Re: Permit Application B00154511-A

This is an amendment to B00154511.

3.96.3! Ac ±
Plat No. 10273

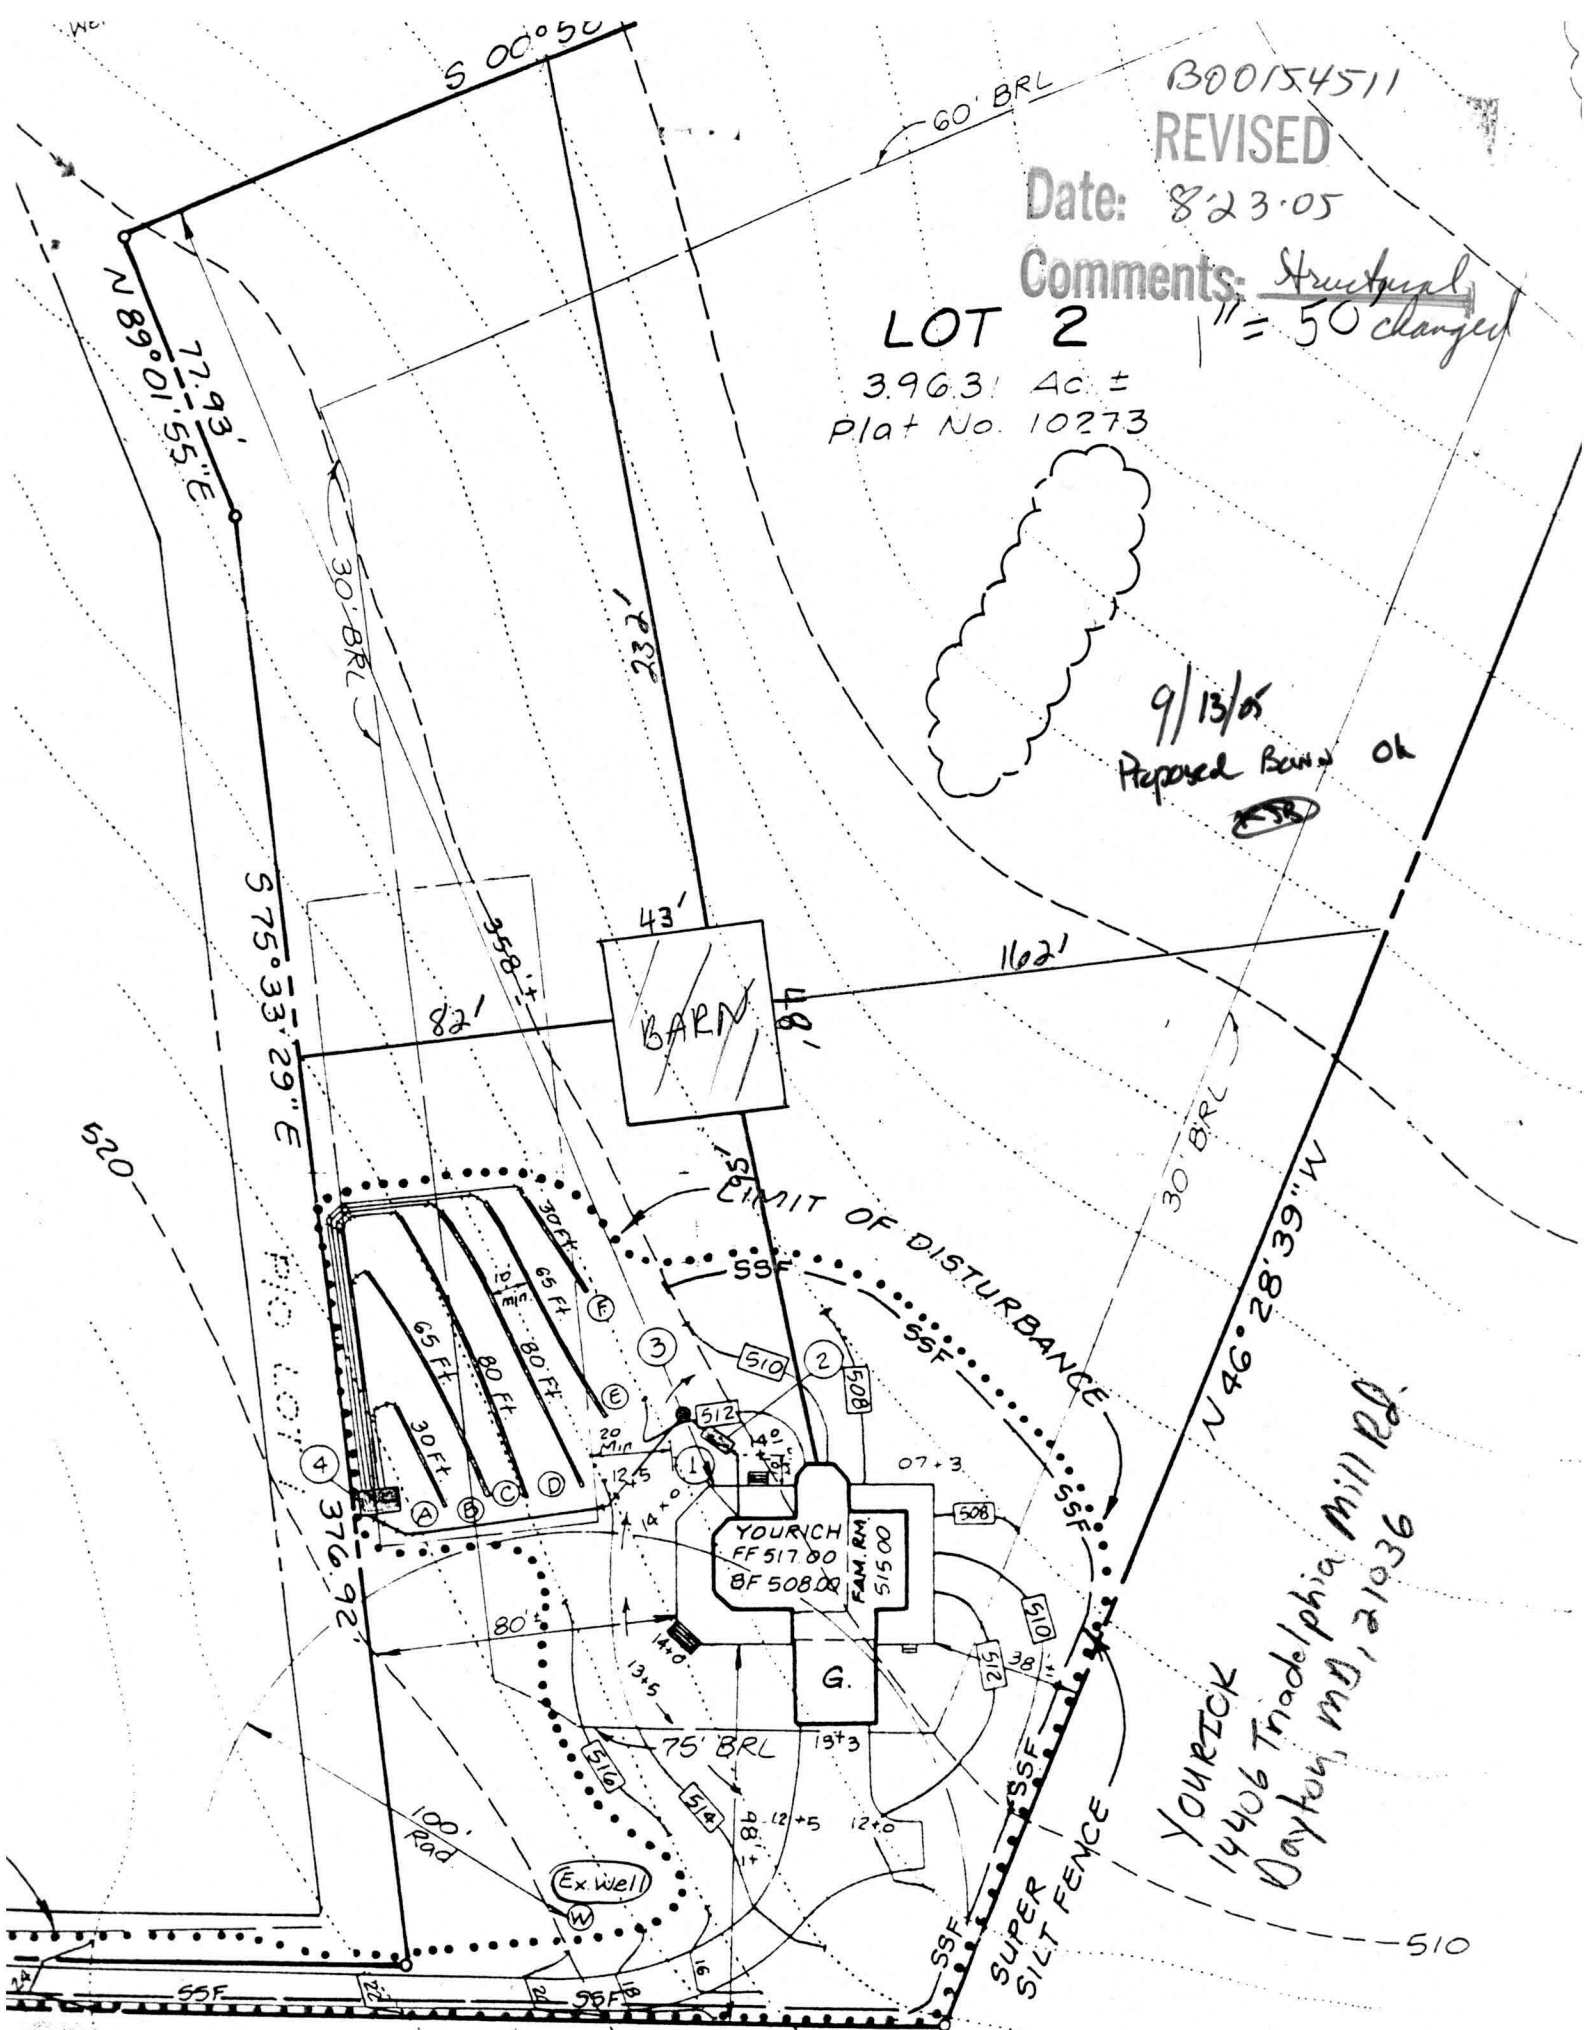
Comments: Structural
2 " = 50 changed

1. New contractor: P.H Drayer Co., Inc., 4111 Lander Rd., Jefferson, MD 21755. Phone 301-473-4466. If there are any questions regarding the building/construction plan, please contact Mr. Pete Drayer directly.
2. The construction design has changed (trusses and side wall construction)
3. Dimensions of the barn. 48 ft x 36 ft with a 7 ft overhang (total 48 ft x 43 ft).
4. Roof will be metal instead of shingle.
5. No garage door opening in end of barn
6. Finished loft space will only be 24 ft x 12 ft.
7. Floor plan has also changed.
8. The location of the barn has changed from the original submission. See revised plot plan.

3.96.31 Ac ±
Plat No. 10273

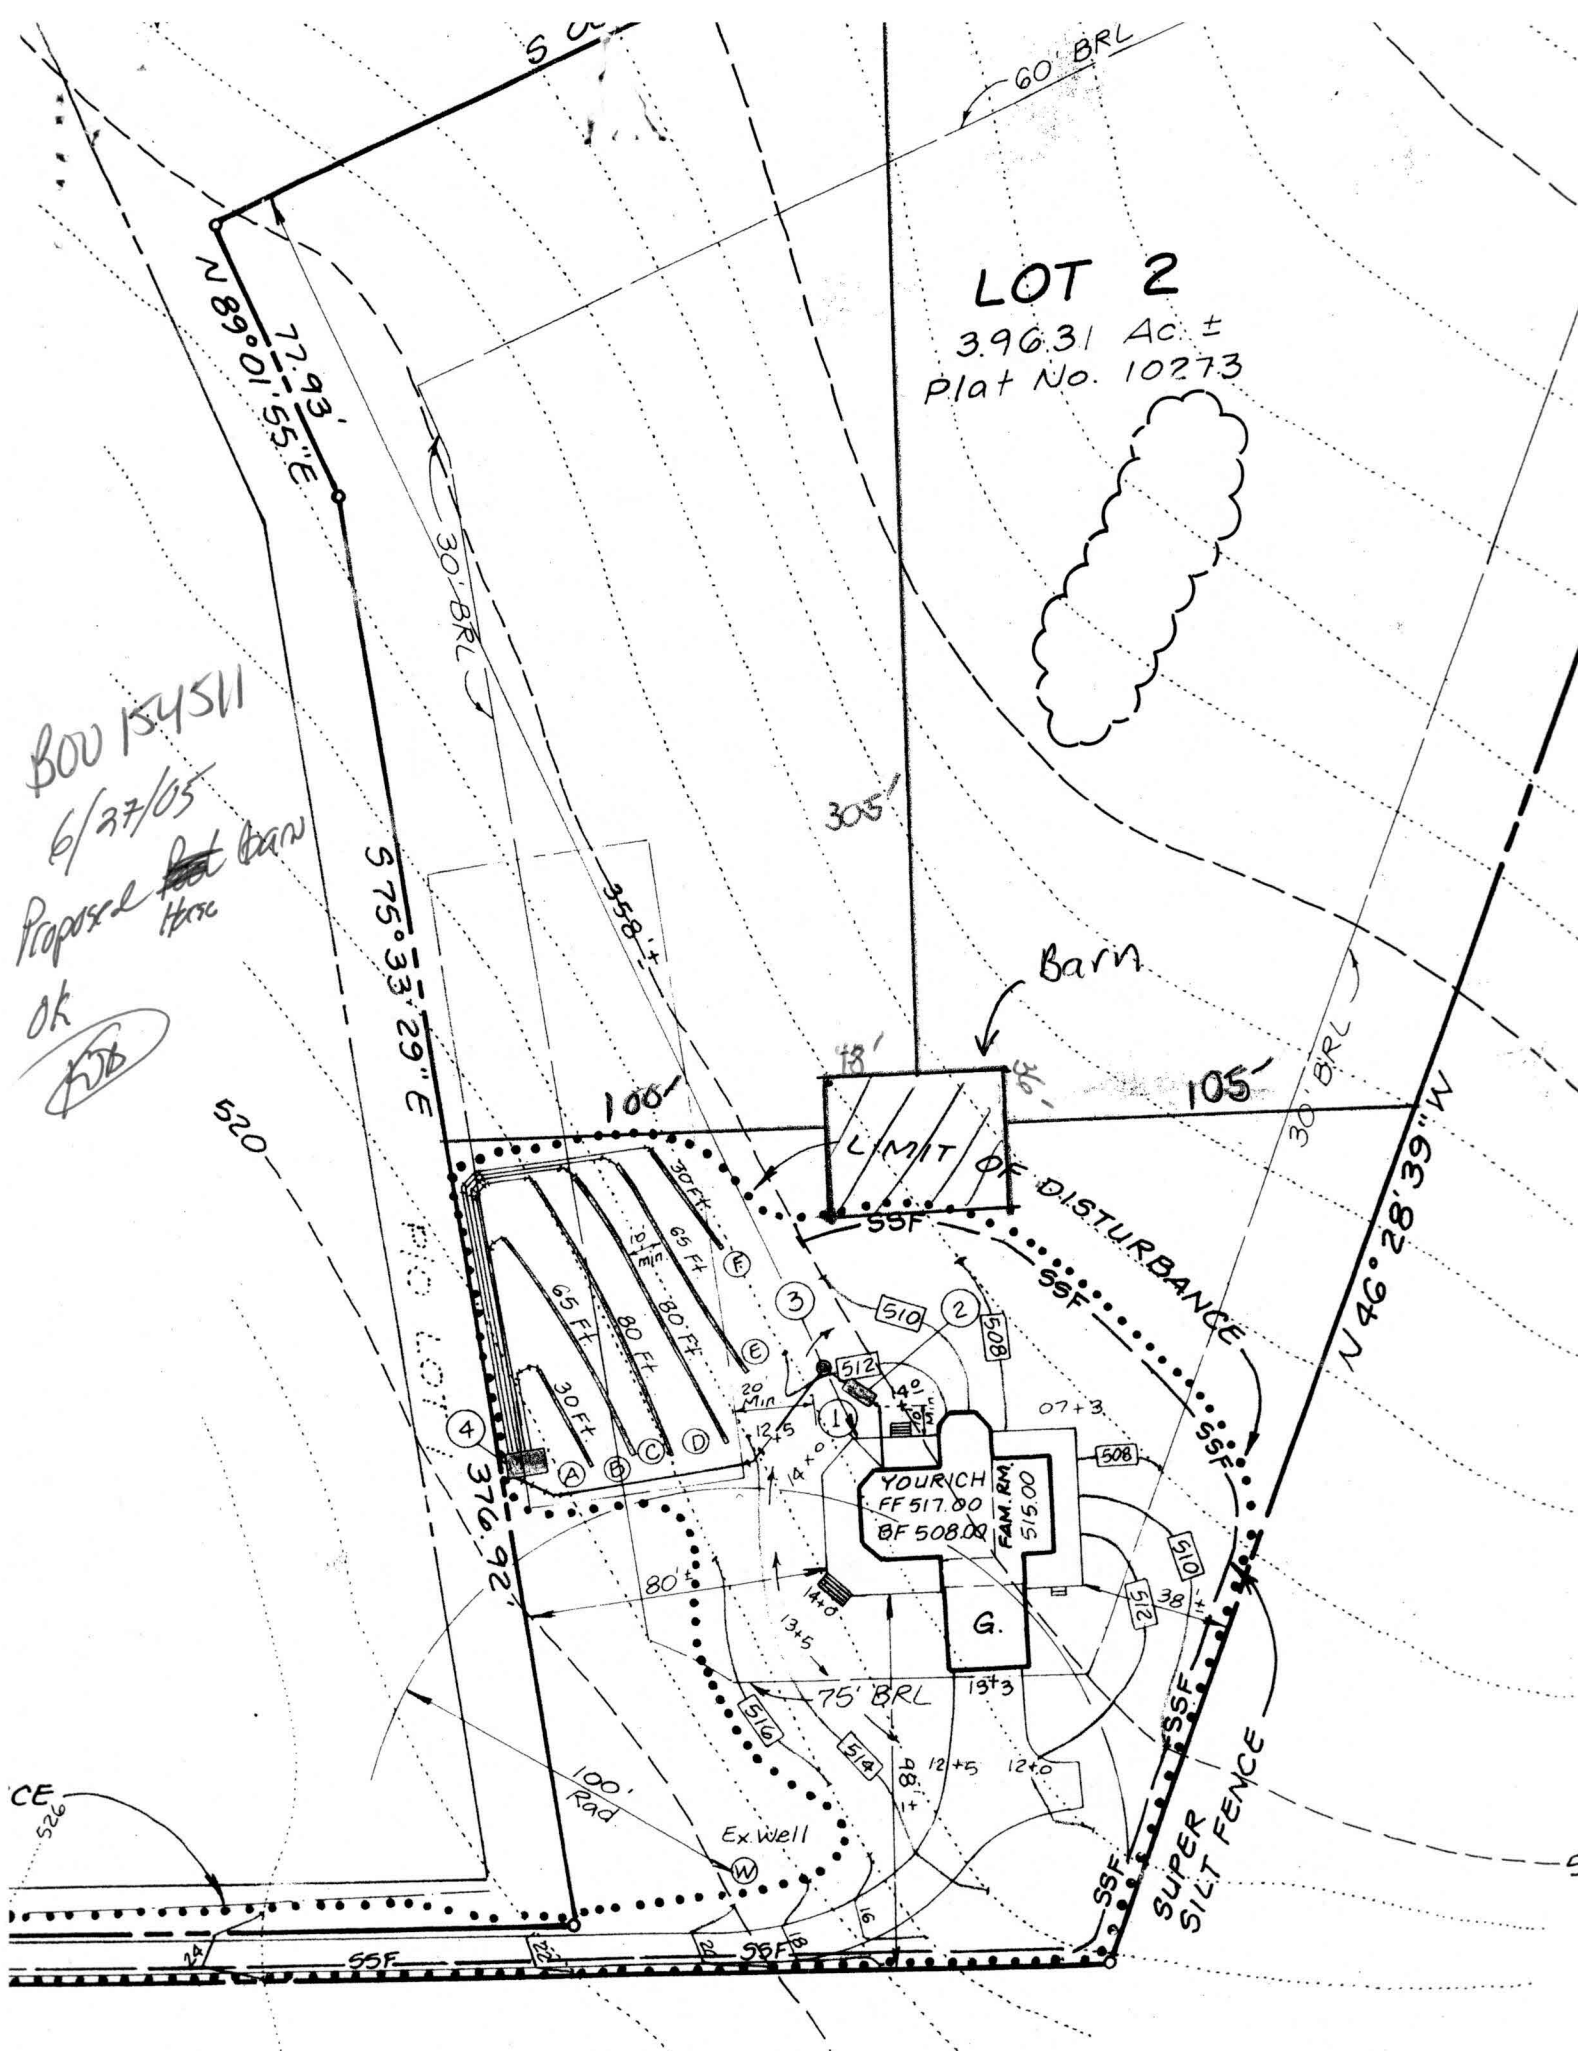
BOU 154511
6/27/05
Proposed ~~not~~ train
here
OK
KDB

Total linear feet of trench ~~490~~
300' required ~~250~~ feet
REV MR 9/5/01
Width of trench(es) 3.0 feet
Depth of trench(es) 3.0 feet
